Mid Sussex Local Plan 2014-2031 –

Site Allocation Development Plan Document

Examination Hearing 10 June 2021 – Inspector’s Matters, Issues & Questions

Statement submitted on behalf of the Hamsland Action Group (HAG)

Figure 4: Location Plan, site access route and calculation of parking capacity

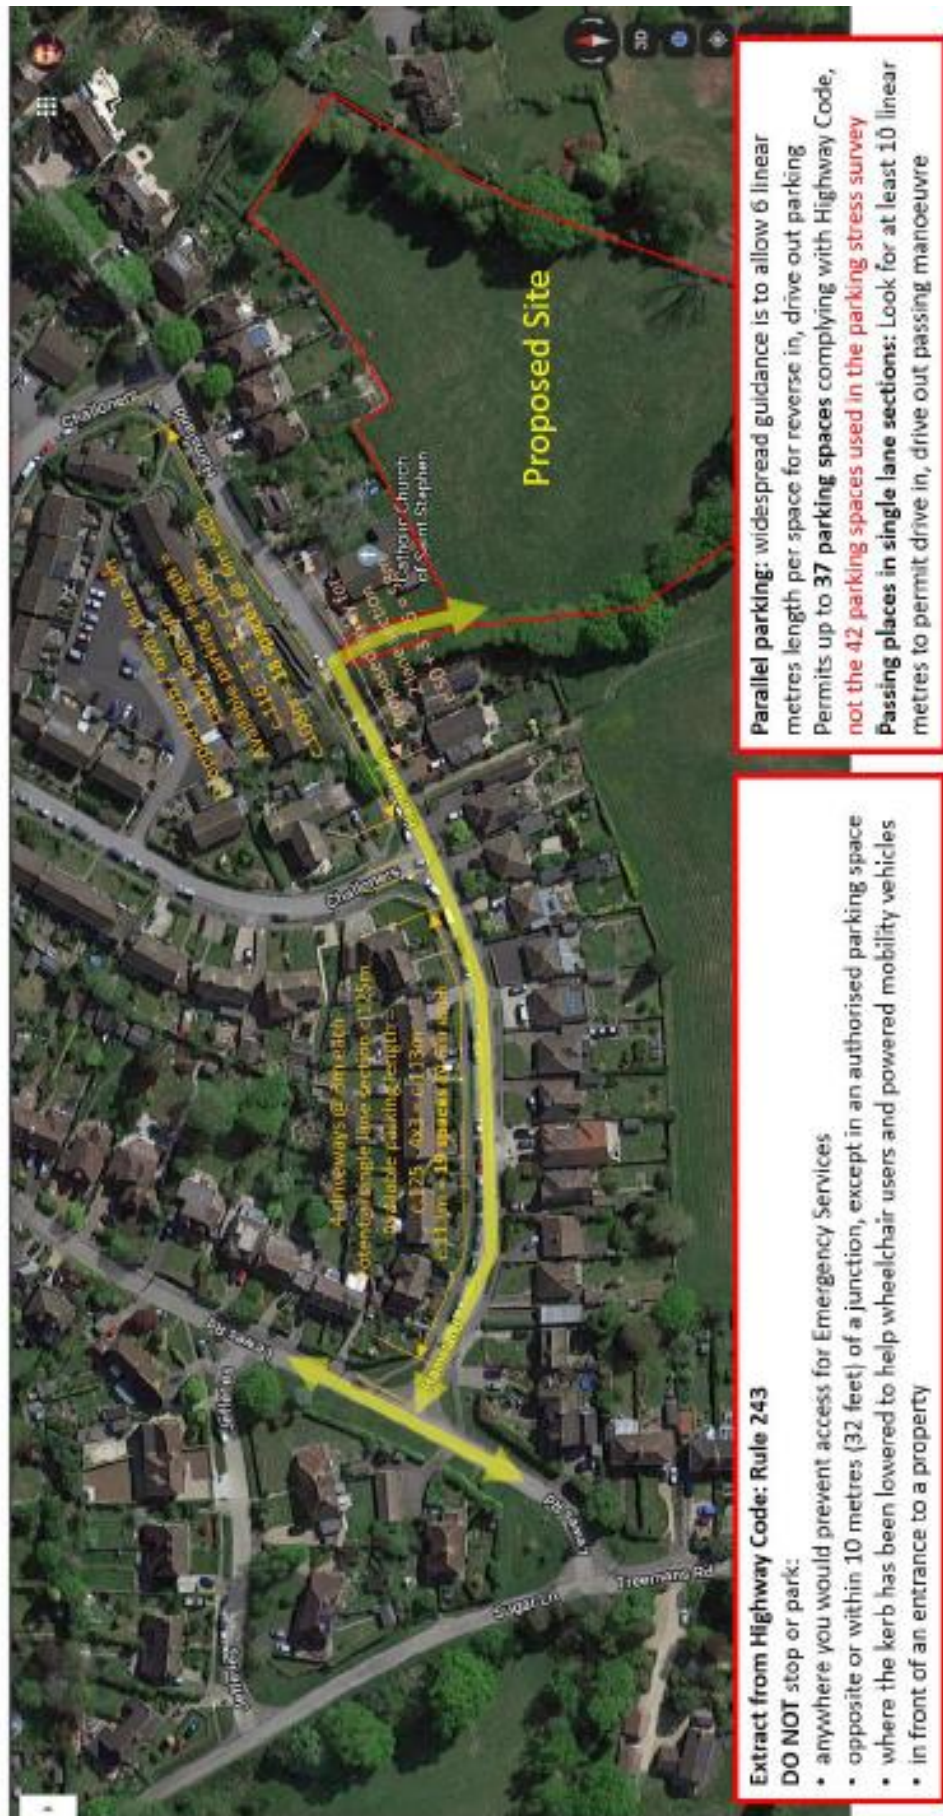
- The survey only counted on-street parking, so will not have counted any residents’ cars in the eastern section of Hamsland that were parked at that time off-street in St Stephen’s Church car park. The Church is now derelict, and the car park is fenced off, so those cars are now all parked on-street on Hamsland.

- The analysis reported a potential capacity of 42 cars that could be parked along the full length of Hamsland. This analysis contains several errors. The survey records two drop kerb driveways, both on the western part of Hamsland. There are, and have been for many years, four drop kerb driveways along the western part of Hamsland, and there is also the drop kerb pedestrian crossing in the eastern section of Hamsland opposite St Stephen’s Church. The full length of Hamsland includes three junctions, namely with Lewes Road, with Challoners and with Challoners/Bonfire Lane. Rule 243 in the Highway Code rules out, amongst other things, parking within 10m of a junction, which appears to have been ignored by RPS. Whilst I have not found any WSCC guidance, there are numerous examples of guidance (including ESCC) which recommends an allowance of 6m kerb length per parked car for kerbside parallel parking. Taking all these factors into account, the maximum capacity along the full length of Hamsland is 37 cars, not 42. This is shown pictorially in Figure 4 overleaf.

- Correcting these capacity errors, but still using RPS's (implausibly low) maximum on-street parking numbers at this stage, would raise the headline level of parking stress by 8% from 57% to 65%. This is shown below in a corrected version of RPS's Transport Statement Tables 2.4 and 2.5. However, the 'Occupied' numbers in these Tables must be treated with extreme caution as they are implausibly low. They can be reviewed in the context of new data gathered in a new parking survey to reflect current conditions, the description of which is set out in the paragraphs that follow.

Parking survey: 09:15-09:30 Friday 5th February

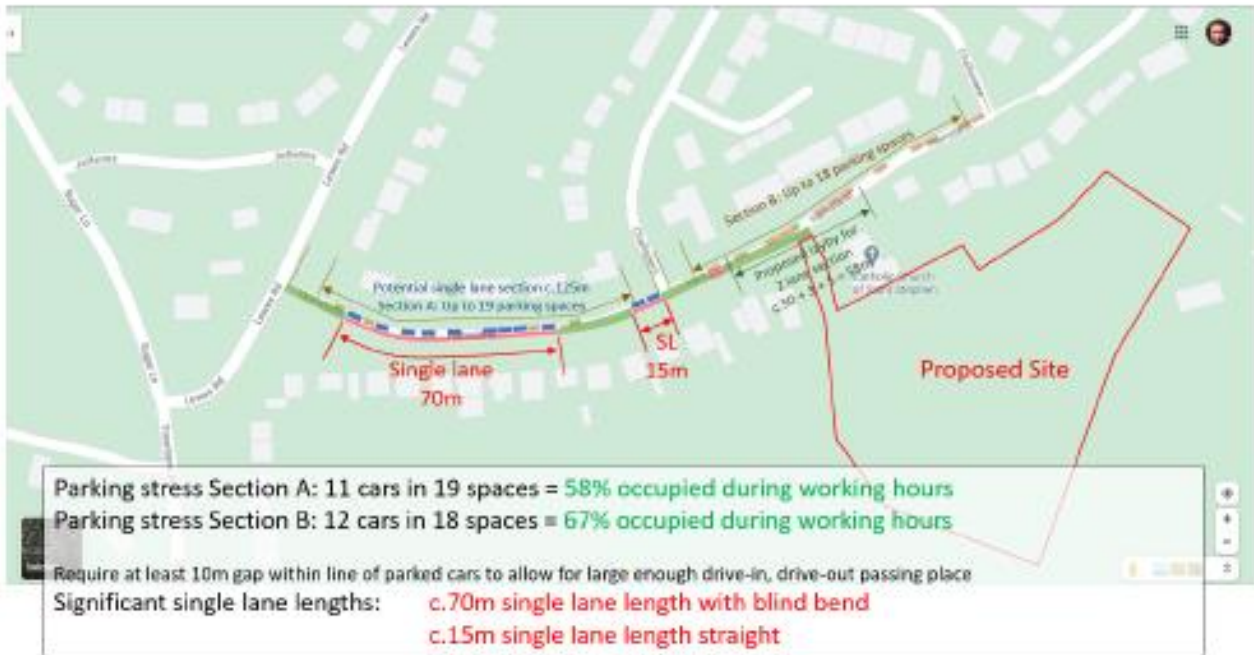
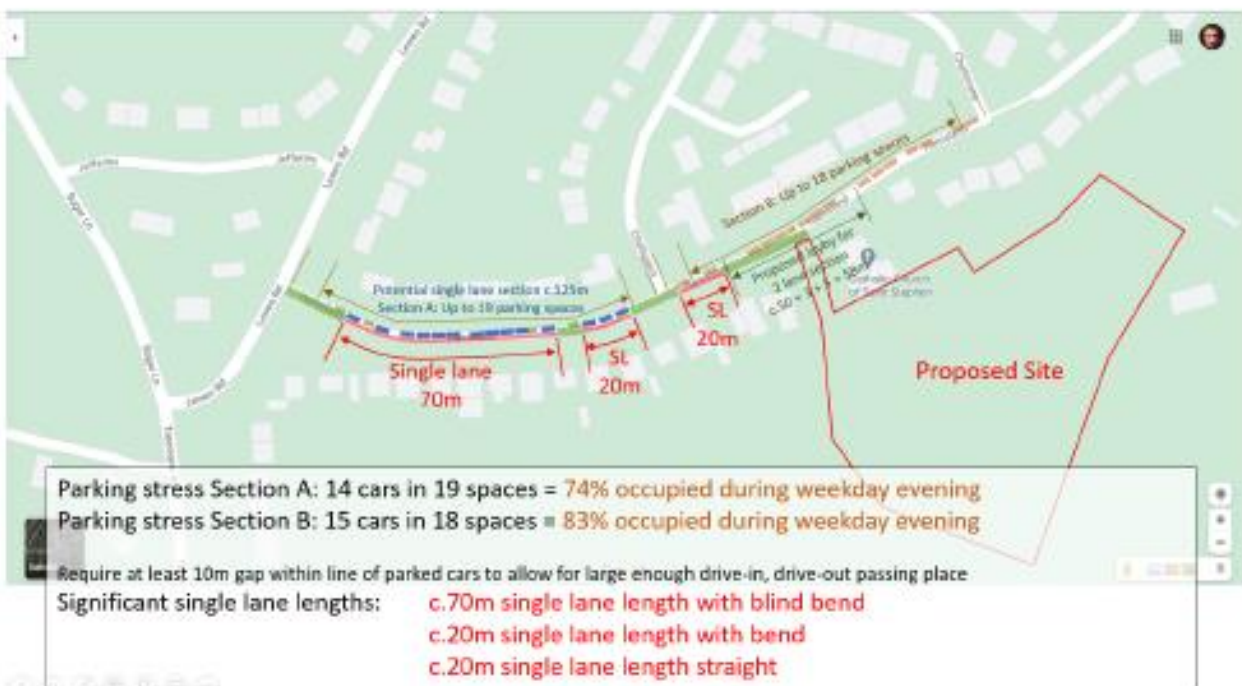
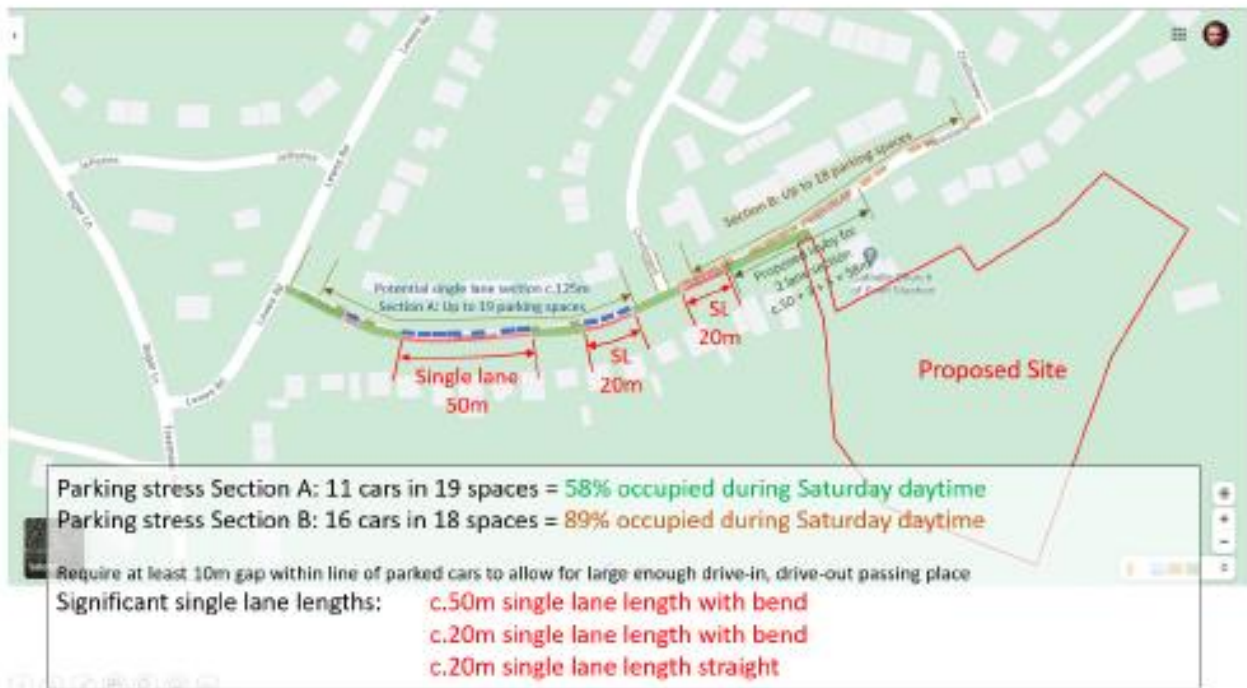
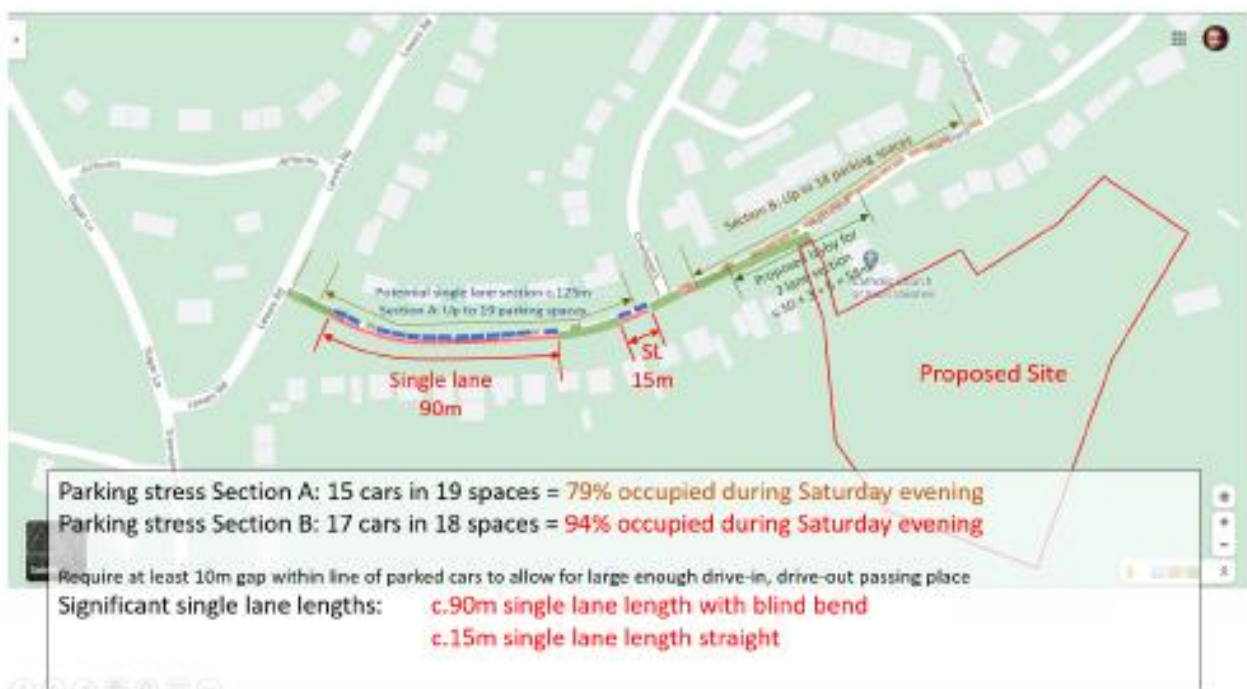
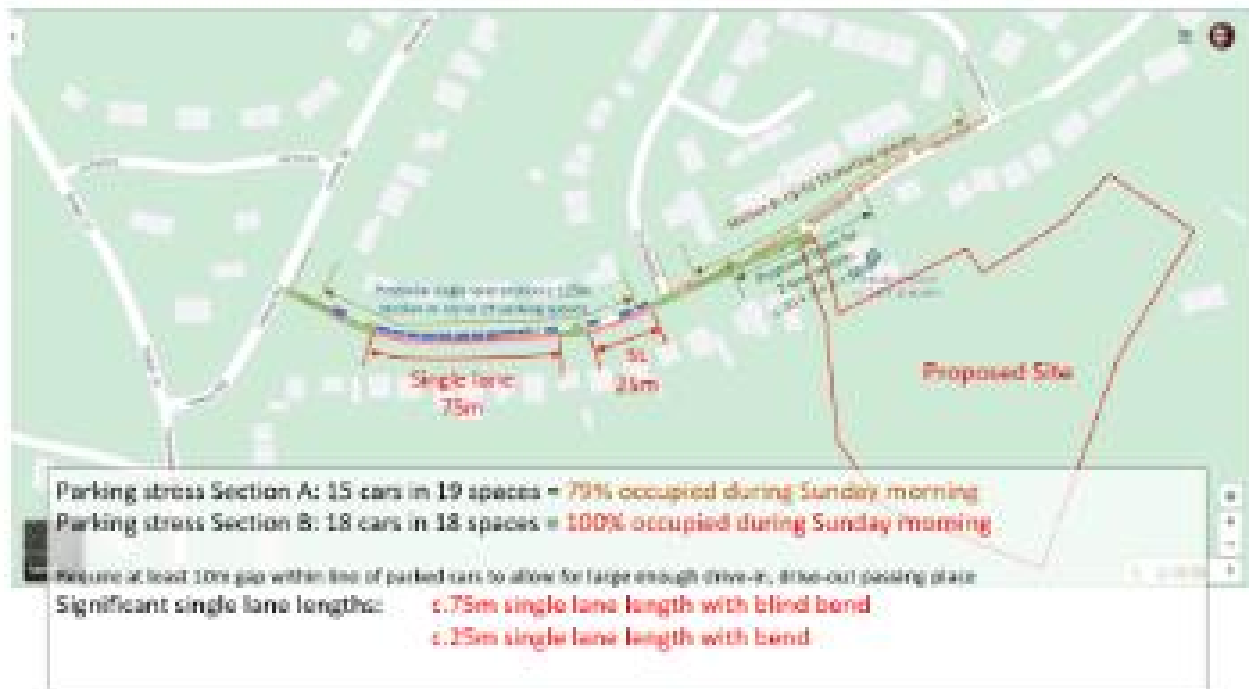
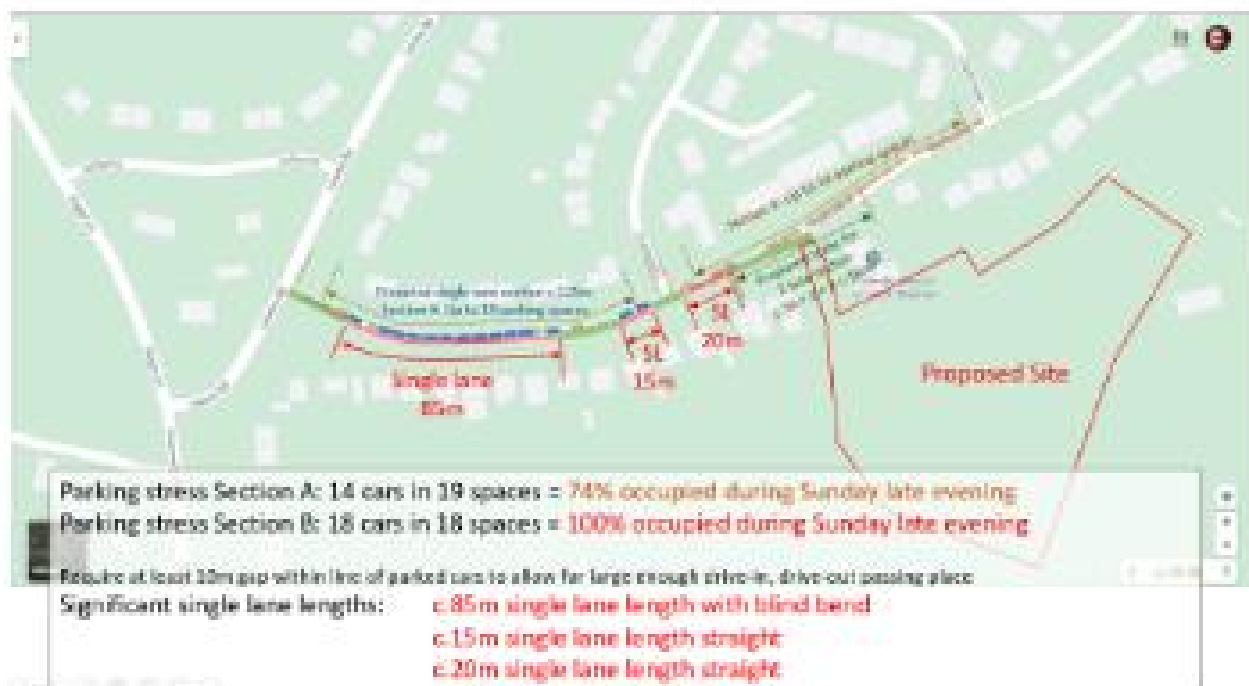
3.25 I used the same on-site methodology as RPS, by marking parked cars on the survey sheet as a dot, but I then transcribed this data into a more spatially representative format back at home, the results of which are shown in Appendix A.

- 3.38 Whilst the weekday daytime occupancy shows some limited overspill parking availability, in this case up to 6 vehicles, all of the evening and the weekend daytime data show little or no spare capacity. The survey sheets show that demand is such that vehicles are already being displaced into and are parking in the 10m junction zones at times, which cannot be an acceptable basis for design.
